June 9, 2022

Addendum 1

RE: ABC Store No. 4 & Warehouse
Craven County ABC Board
Bridgeton, Craven County
MBFA No: 2102

A1 SITE PLAN - NEW WORK

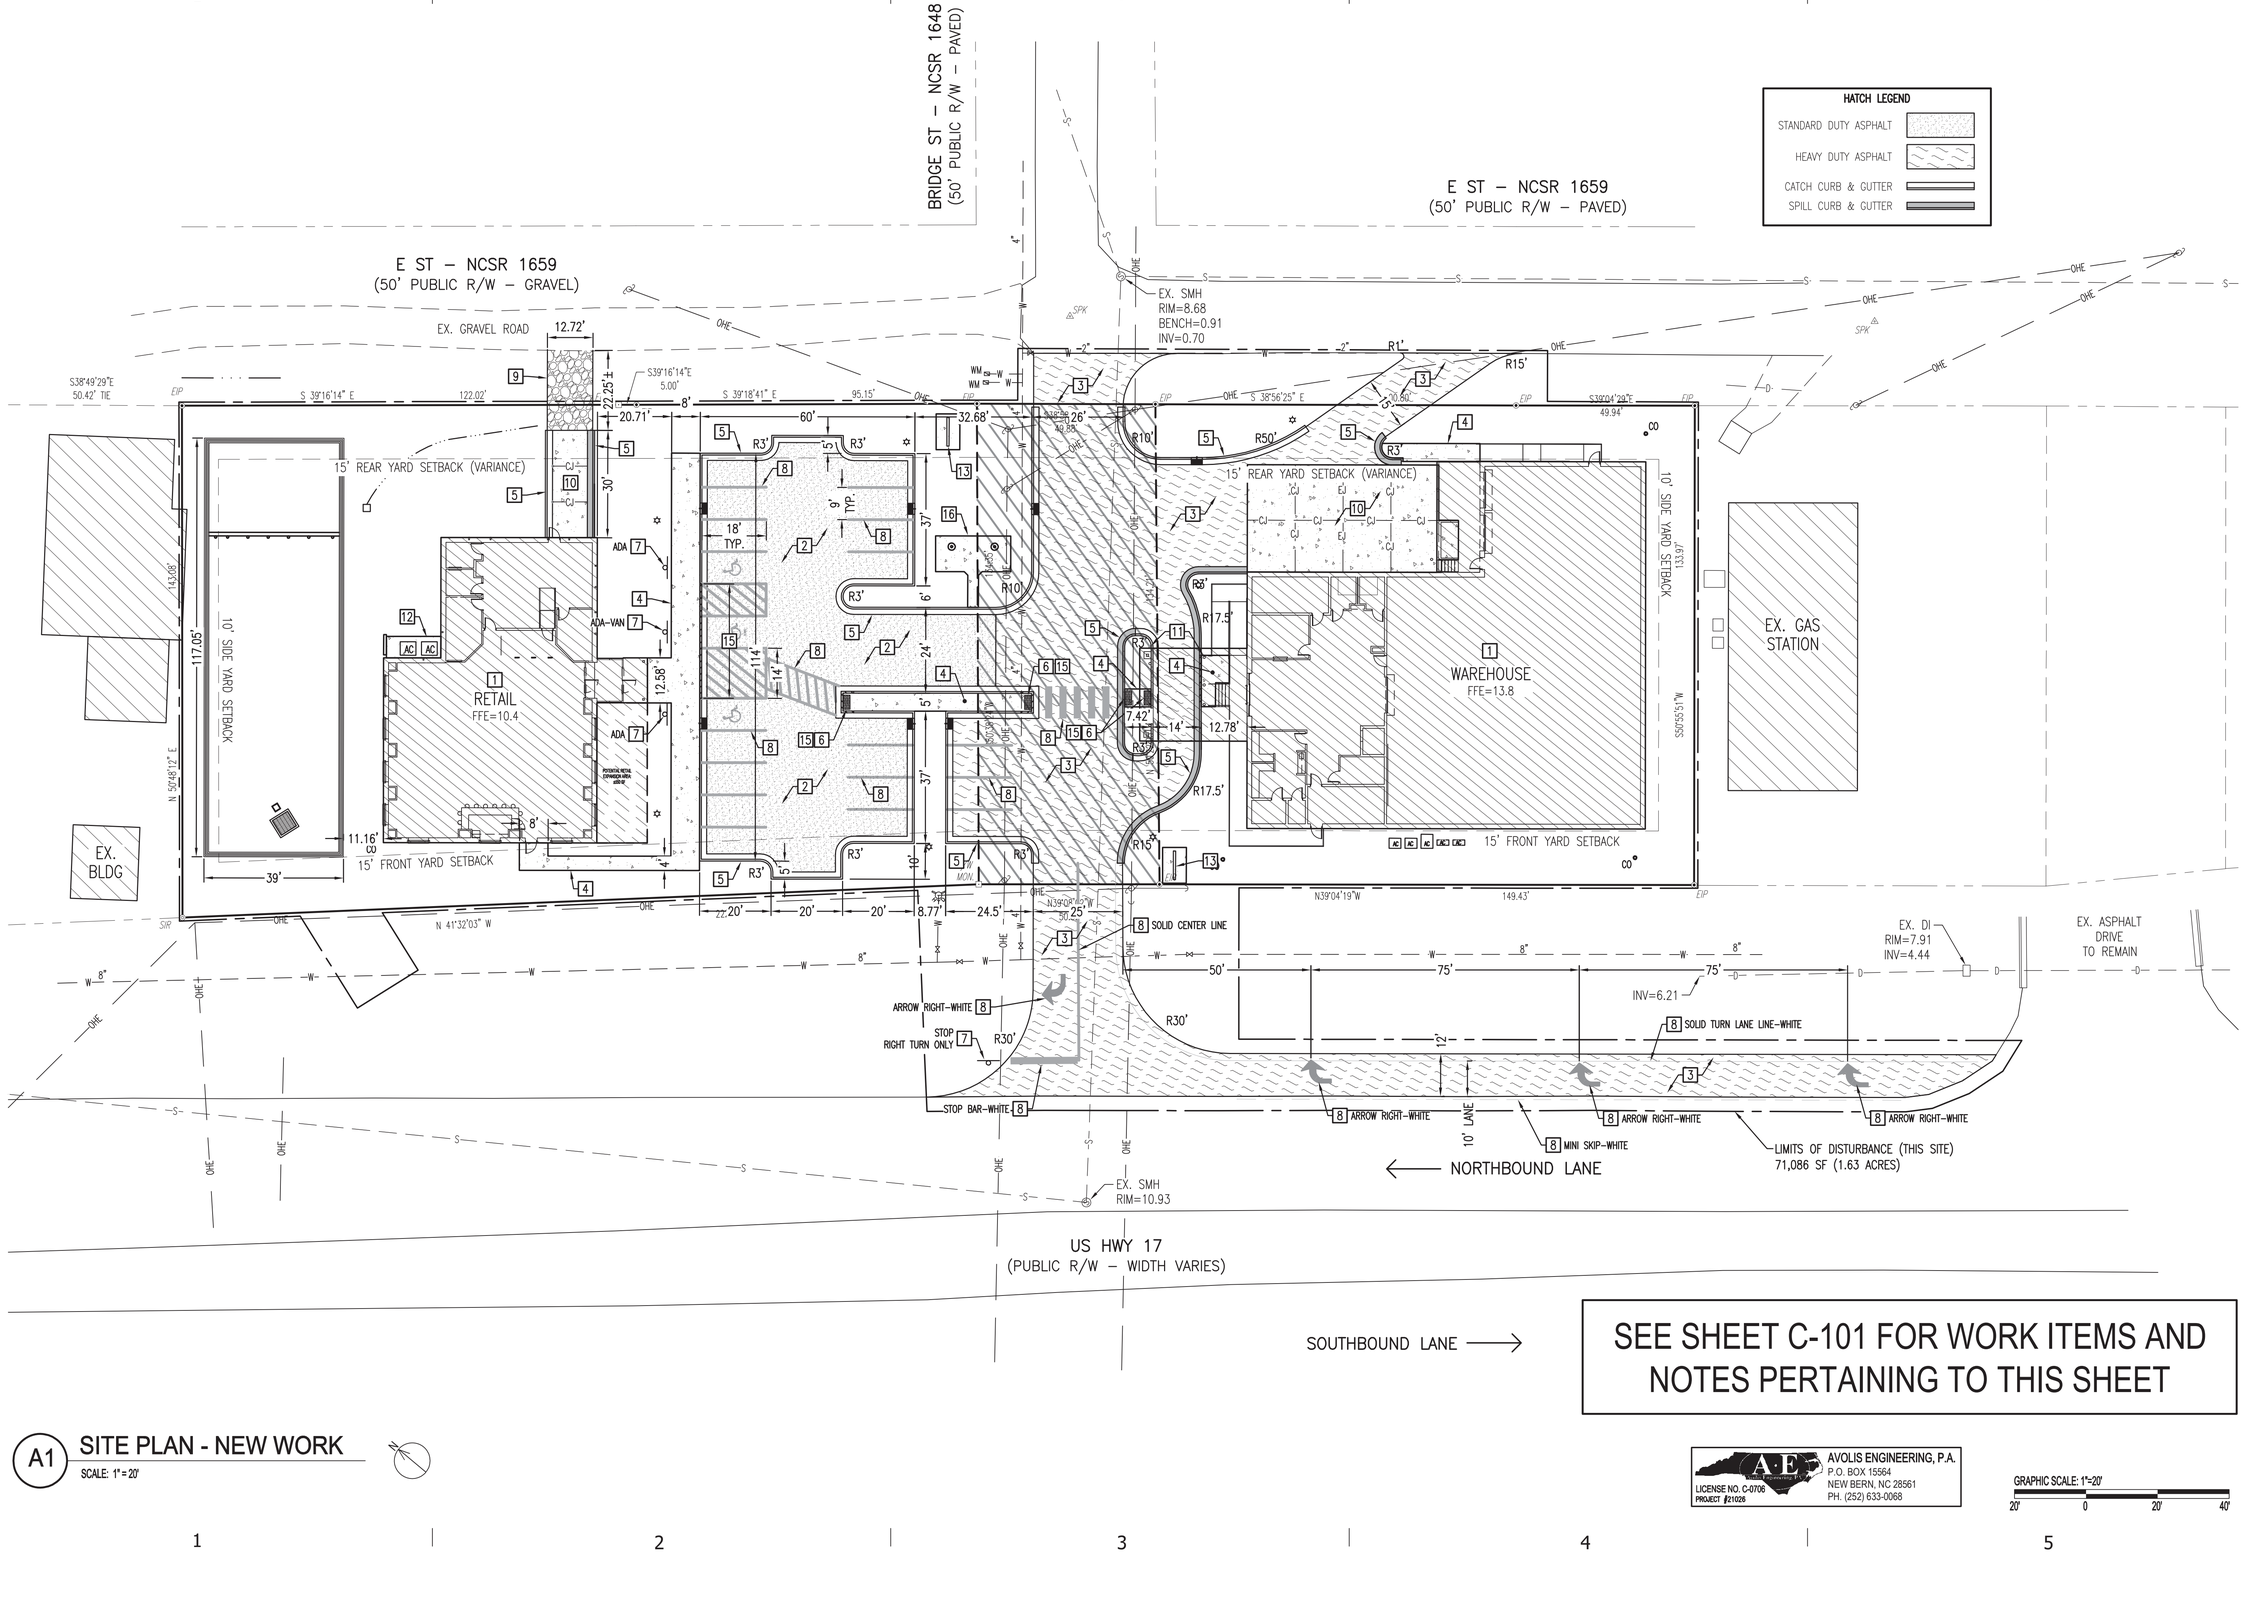
Item 7: Reference **Sheet CS101, Keynote 13**. Omit the monument sign referenced.

AS101
SHEET 1 OF 2

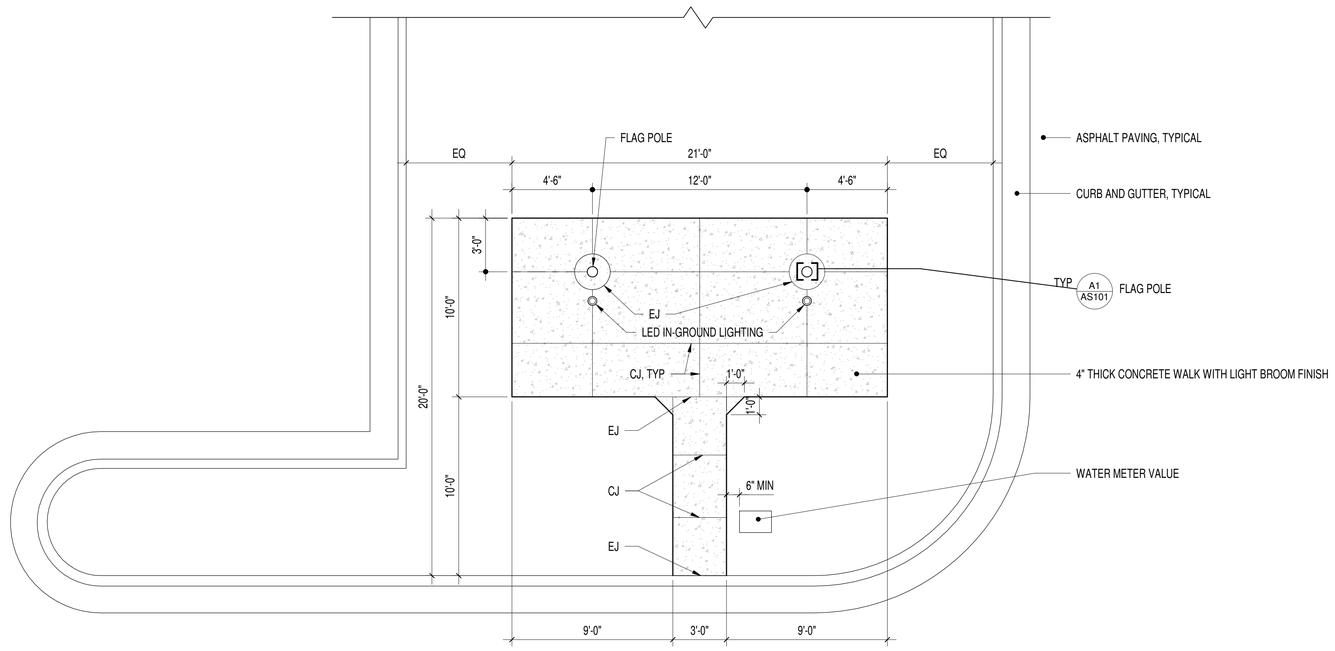
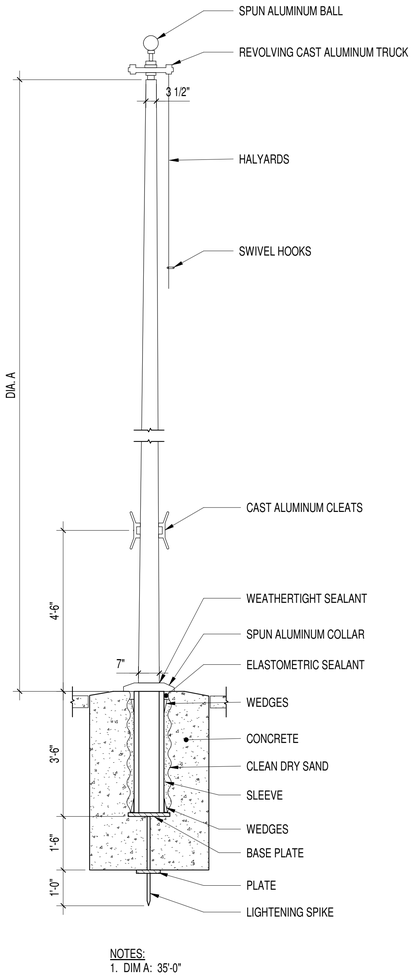
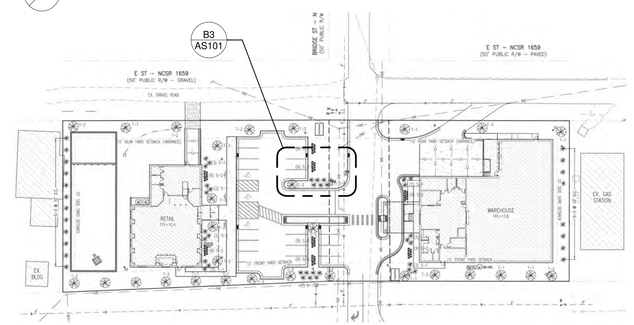
Item 8: Reference **Sheet AS101**. Furnish flagpoles, site walks and lighting. Technical specifications are included in **Section 10 75 00, Flagpoles.**

B3 WAREHOUSE - BOARD ROOM CASEWORK

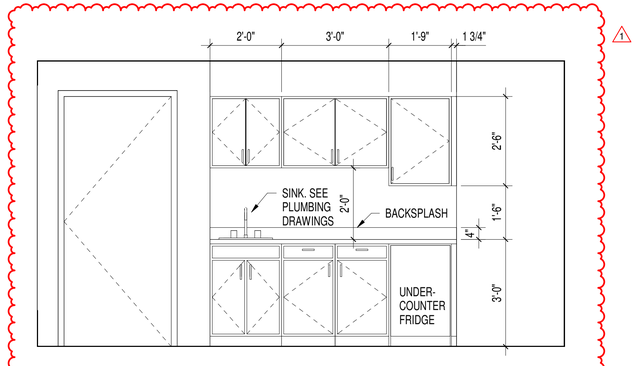
Item 12: Reference **Detail B3/A-402 and Detail A3/A-403**. Coordinate Owner furnished refrigerators into millwork fabrications.

A5 TASTING COUNTER ELEVATION

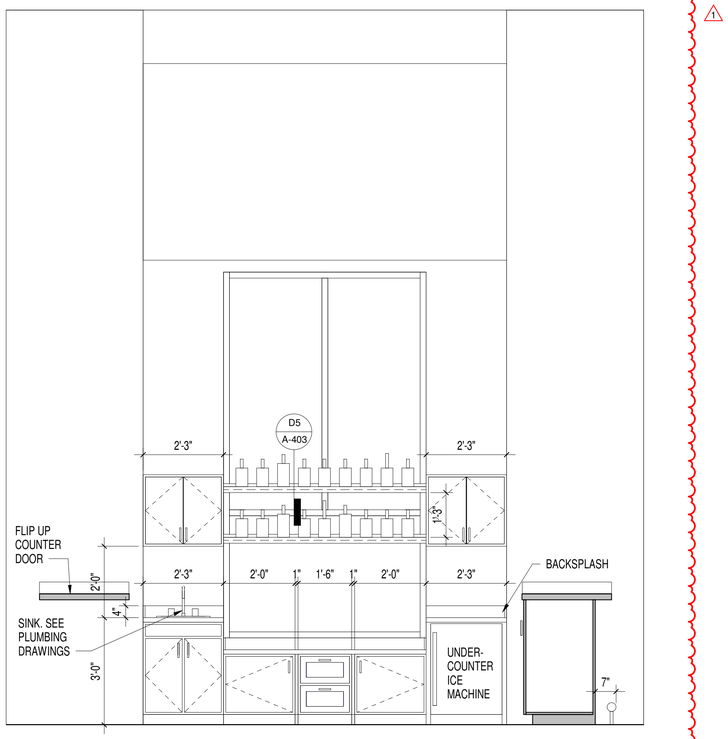
Item 13: Reference **Detail A5/A-403**. Add plexiglass shelving to millwork.

A2 MECHANICAL SCREEN WALL DETAIL
SCALE: 1 1/2" = 1'-0"

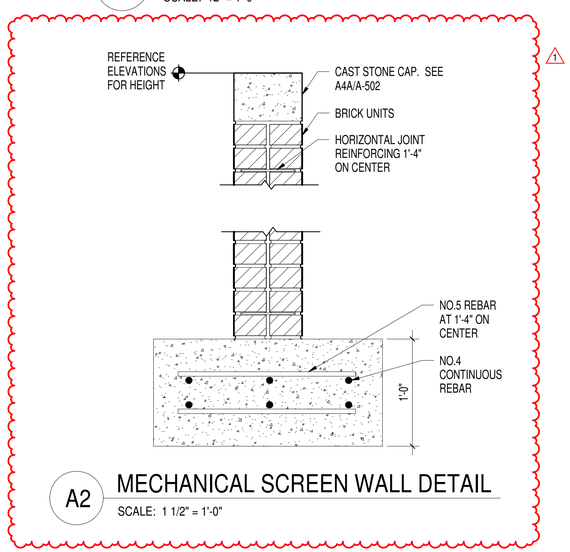
Item 14: Reference **Detail A2/A-502**. Add a concrete footing to mechanical screen walls.

1 ELECTRICAL POWER & RECEPTACLES PLAN
SCALE: 1/8"=1'-0"

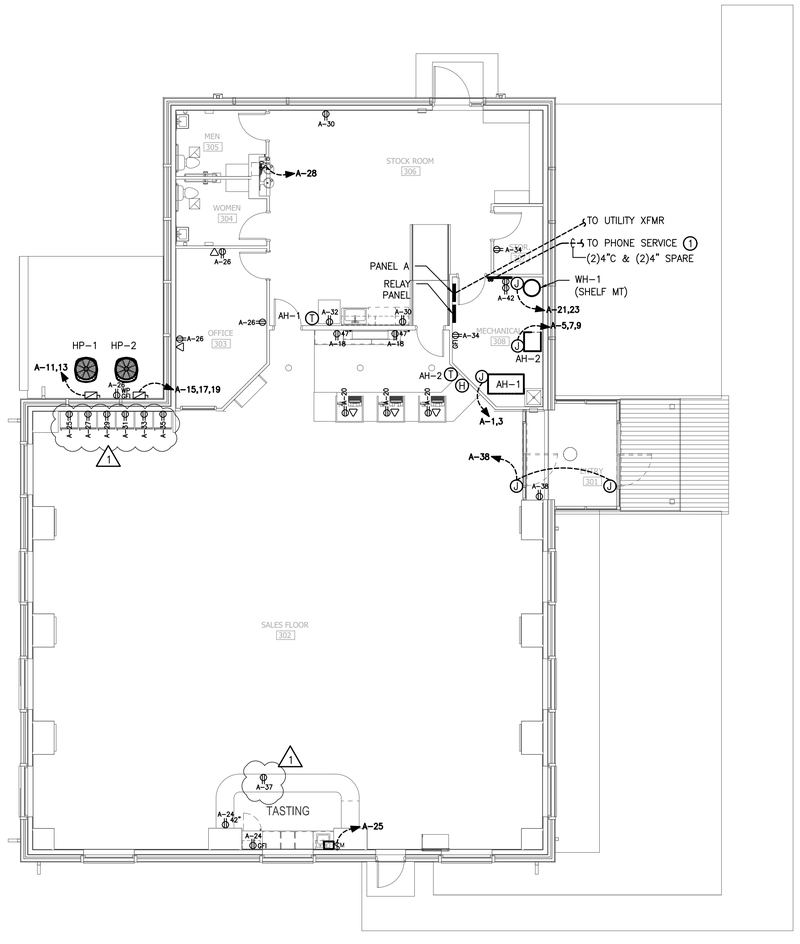
Item 21: Reference **Detail 1/E-101**. Add a 120 volt receptacle and cable TV/data raceway at Sales Floor 302 for the electronic visual display furnished by the Owner outside Office 303.

1 ELECTRICAL RISER - RETAIL STORE
SCALE: N.T.S.

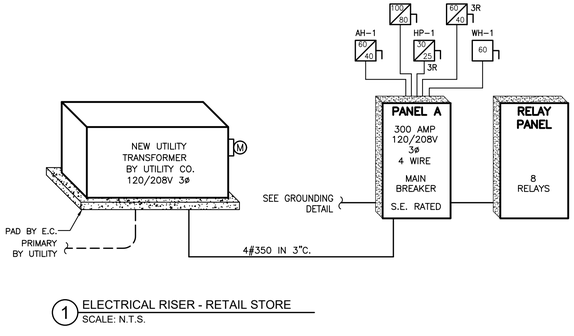
Item 23: Reference **Detail 1/E-301 and Detail 1/E-302**. Allow for 200 linear feet of secondary conduit and cable for both buildings between each Panelboard A and the two transformers set by the utility.
